UNITED STATES PATENT AND TRADEMARK OFFICE

Office Action Summary

10/651,228

DETAILED ACTION

Fig. 1a
(PRIOR ART)

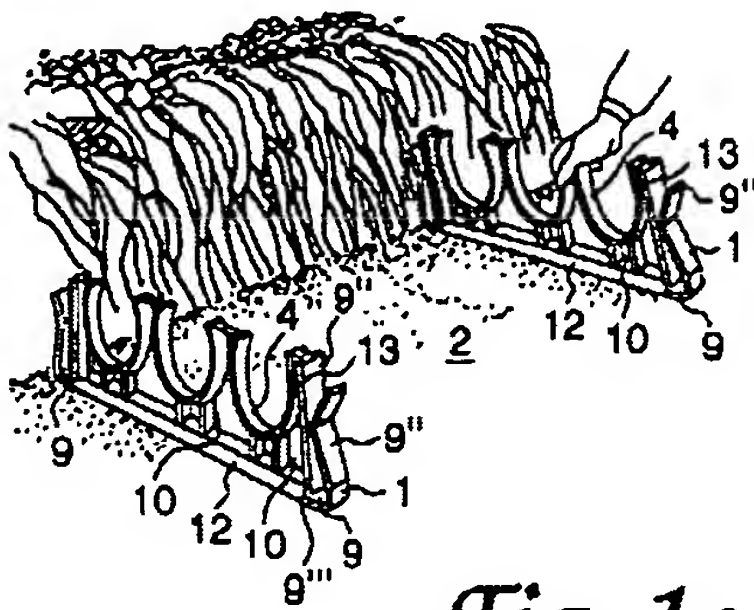
As discussed above, Cogdill teaches all the elements except the use of the apparatus with a trench having non-cohesive soil. Examiner notes that applicant is not claiming merely the intended use, but is positively requiring a trench with non-cohesive soil. Non-cohesive soil is shown in Figs 1a and as taught in col 2 below:

Center bridge
End plates

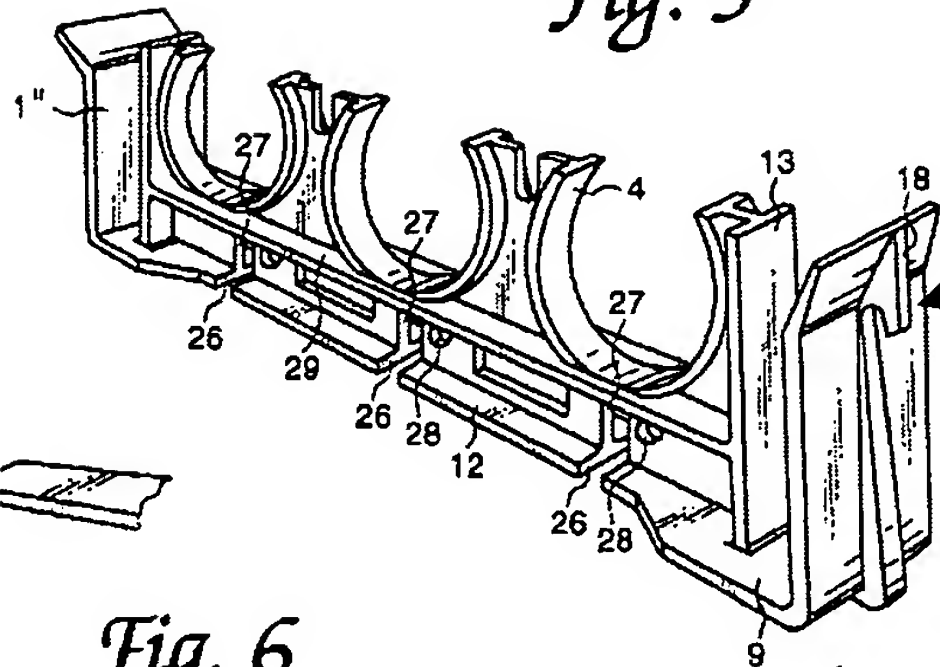
Re claims 1, 34, Cogdill teaches an apparatus capable of holding conduits in a trench having a bottom and a pair of sides, comprising in combination:

a center bridge portion capable of being disposed against the conduits in the trench;

a pair of end plates secured to the center bridge and capable of being disposed against the trench sides, and

a boss on each end plate extending outwardly from the endplate for receiving the bridge.
